Subject: Duke Energy Carolinas, LLC
Oconee Nuclear Station
Renewed Facility Operating Licenses Numbers DPR-38, DPR-47, and DPR-55;
Docket Numbers 50-269, 50-270, and 50-287
Responses to Request for Additional Information for the License Amendment
Request to Revise Portions of the Updated Final Safety Analysis Report Related to
the Tornado Licensing Basis; License Amendment Request: 2006-009

On July 6, 2009, Duke received a Request for Additional Information (RAI) in regards to the LAR [Ref. 2]. This submittal contains Duke's responses to that RAI. Within this document, the attachment contains Duke's responses to the RAI and supporting documentation is provided in the enclosure.

Duke Responses to RAI

AUXILIARY BUILDING ELEVATION 796'-6"

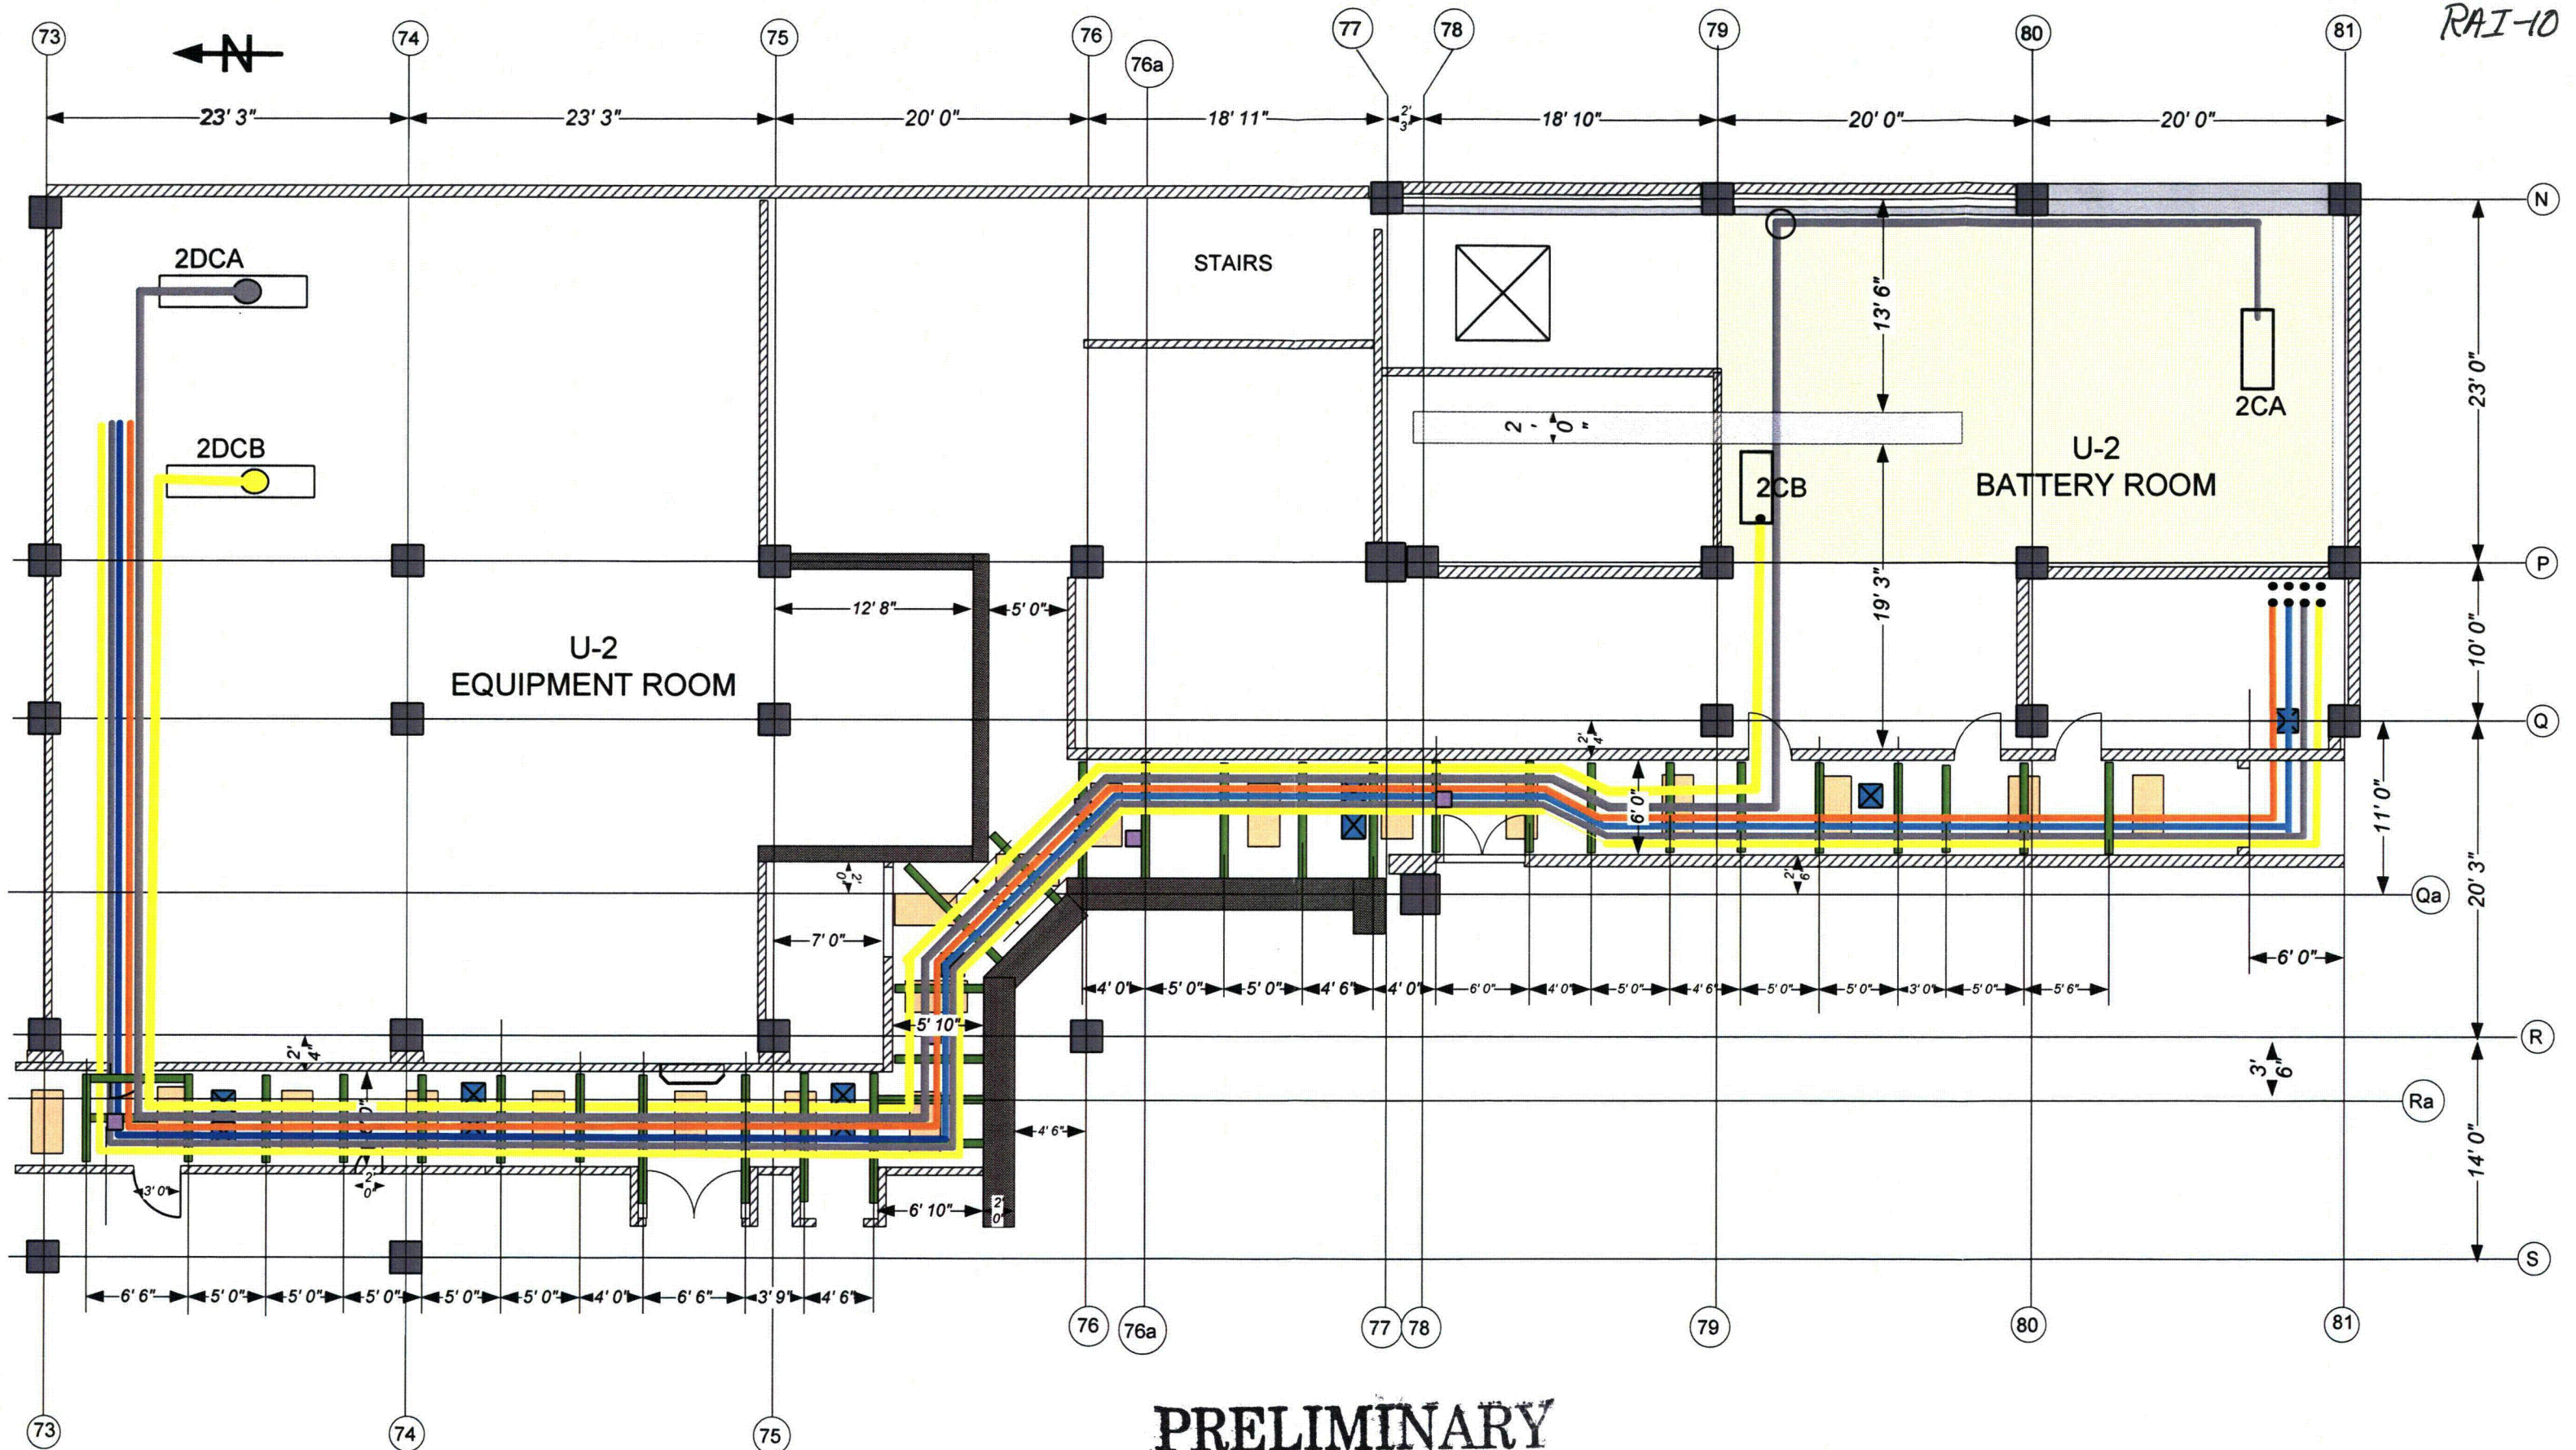
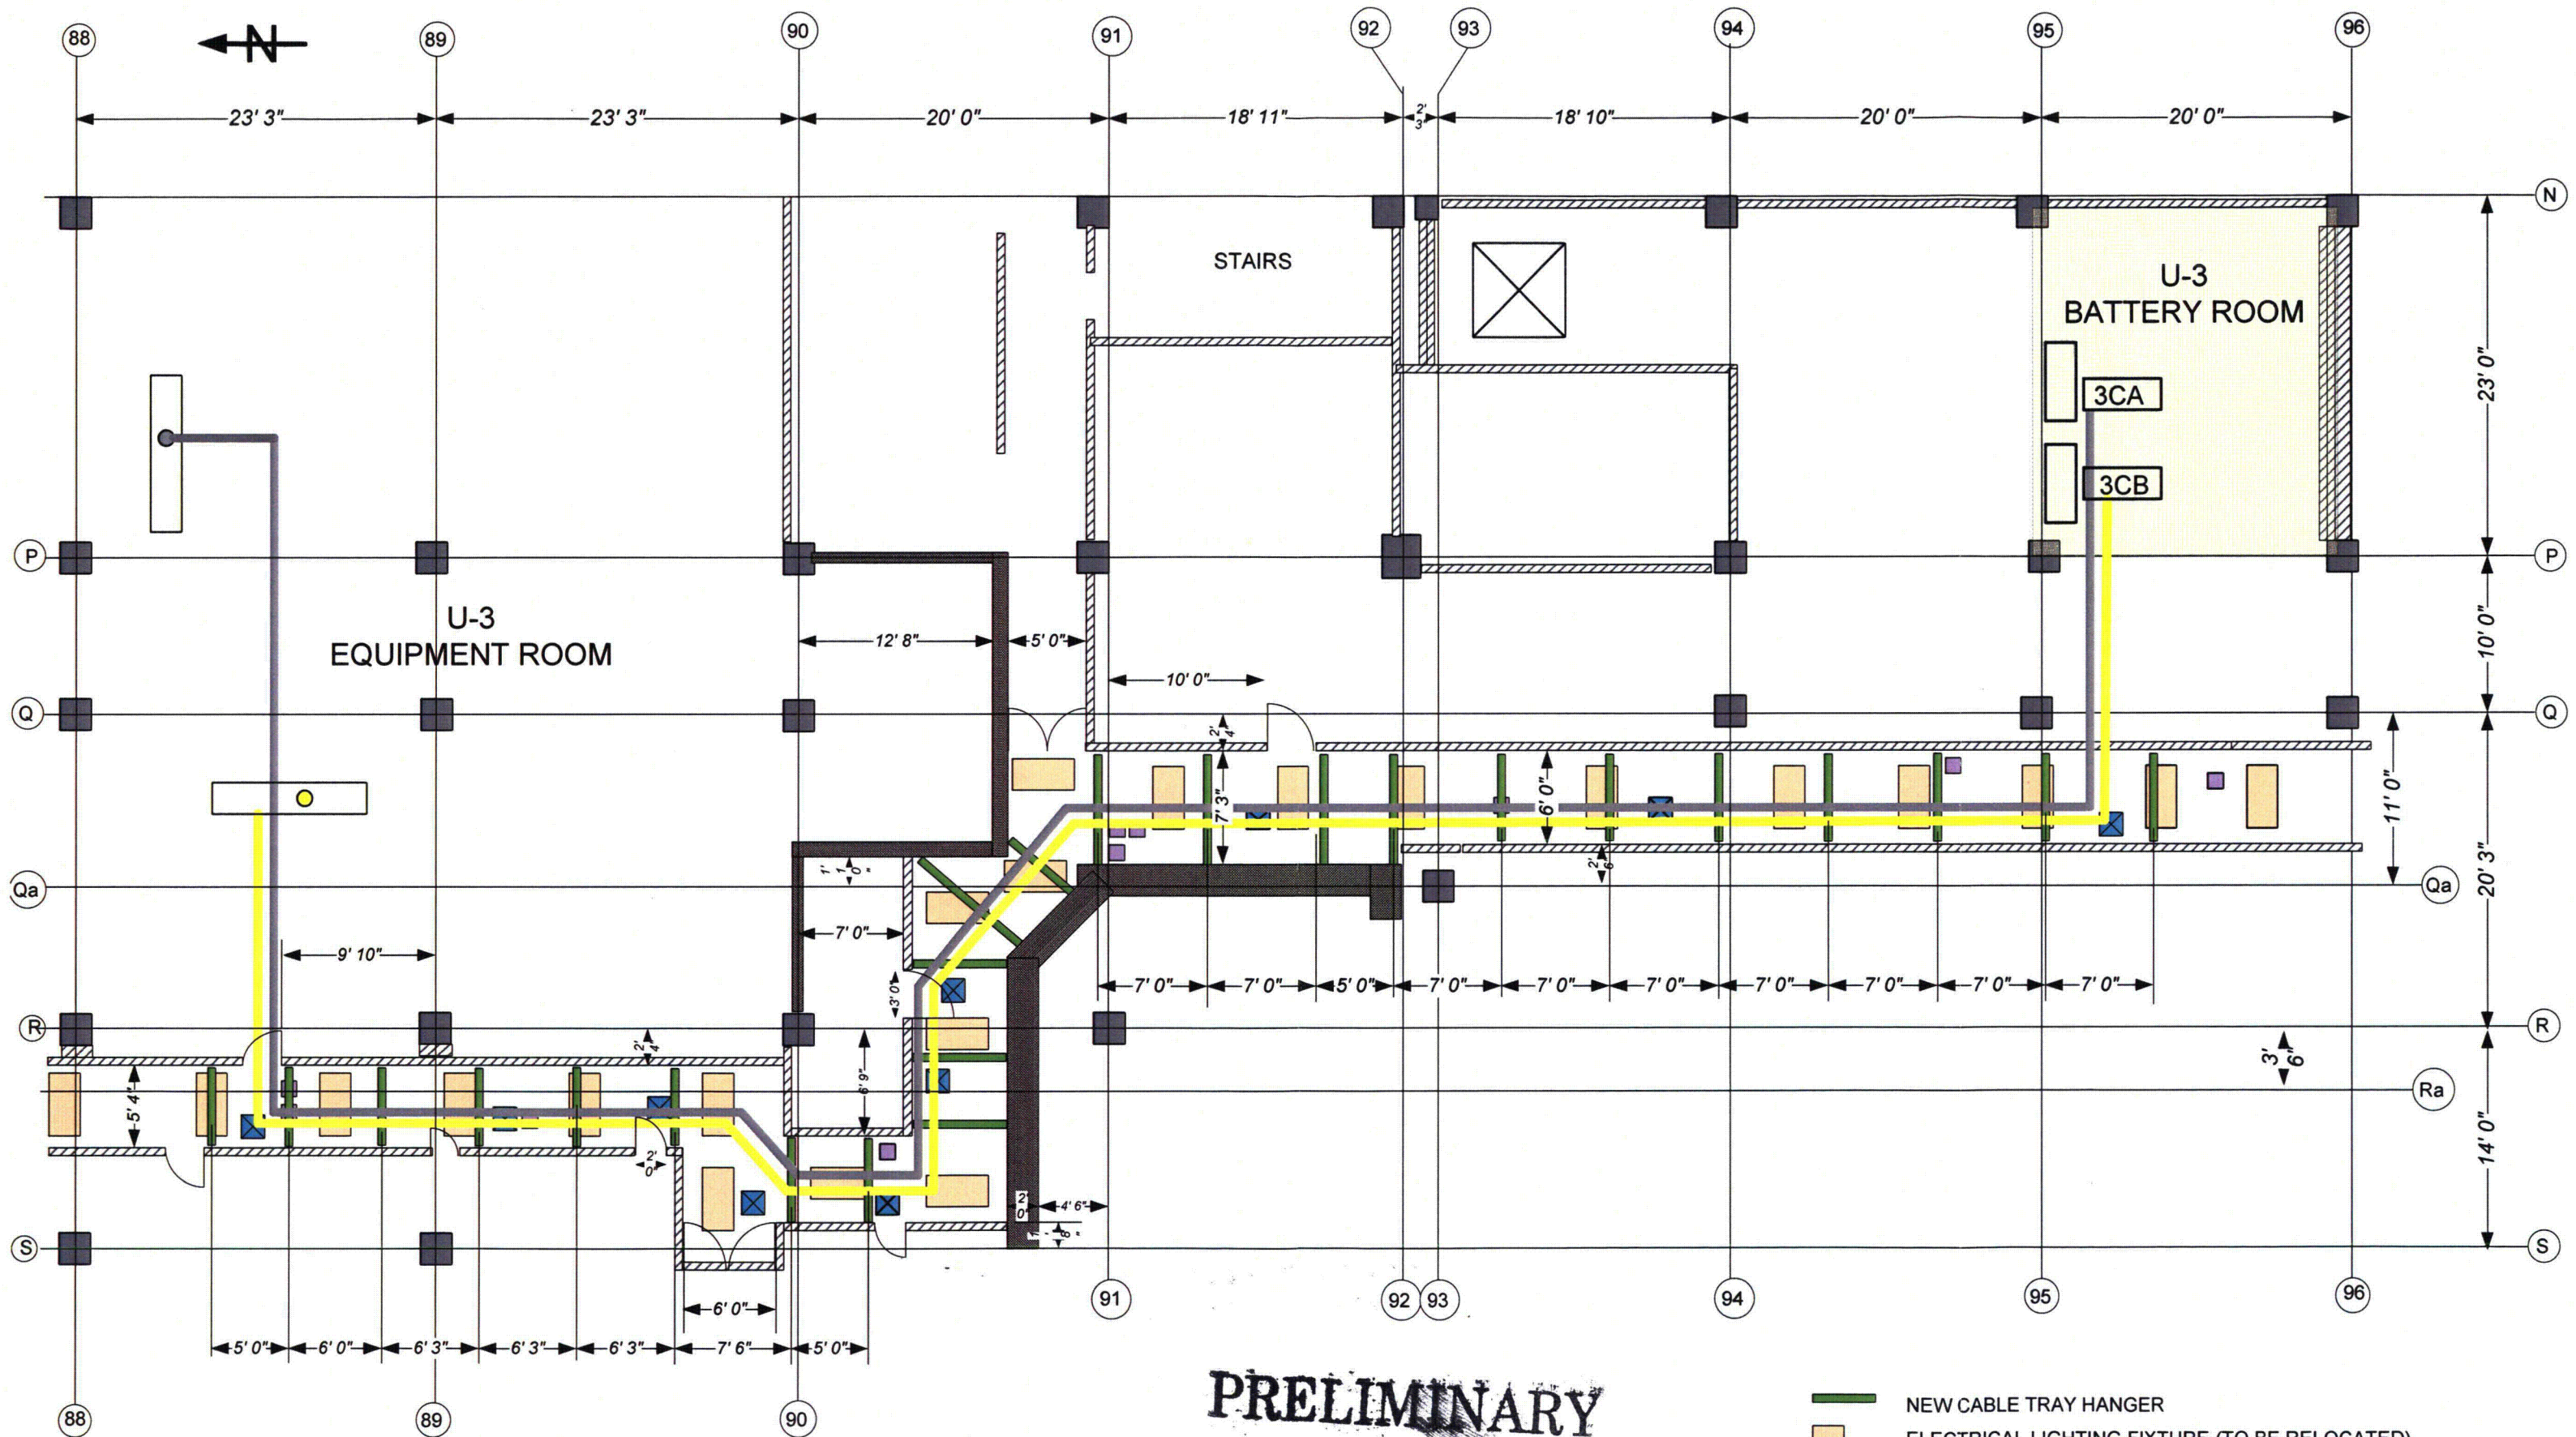
Describe in detail how the 125 VDC vital I&C primary and backup power cables and the KHU emergency start circuitry will be rerouted from the turbine building (TB) to the AB.

This design change provides new routing for the Keowee Hydro Units (KHU) emergency start cables. The existing underground spare cables between KHU and the Oconee Station will be used. For tie-in to control and logic, these underground cables will be extended with new cables between KHU termination cabinets to KHU control panels and Oconee termination cabinets to control panels in the Auxiliary Building. New emergency start cables will be installed from the 230 kV switchyard relay house via a new protected underground duct bank to the PSW switchgear building and, underground via protected duct bank, to the Auxiliary Building control panels.
